Proposal for amendments to Regulation No. 79 (Steering equipment)

Proposed changes with regard to the implementation of technical specifications for Lane Departure Warning Systems (LDWS)

Note: The text reproduced below was prepared by the expert from Germany in order to introduce in Regulation No. 79 technical specifications on Lane Departure Warning Systems (LDWS) taking into account the discussions and agreements of the GRRF informal on AEBS / LDWS achieved so far. The modifications to the existing text of the Regulation are marked in ***bold and italic*** characters.

Model A

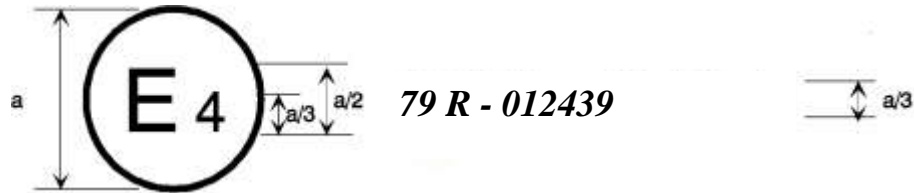
***79 R(7) - 012439***

The above approval mark affixed to a vehicle shows that the vehicle type concerned has, with regard to steering equipment, been approved in the Netherlands (E4) pursuant to Regulation No. 79 under approval No. 012439. The approval number indicates that the approval was granted in accordance with the requirements of Regulation No. 79 incorporating the 01 series of amendments. ***In the case the requirement of Annex 7 are also fulfilled shall the letter “R” a number “7” in brackets following***
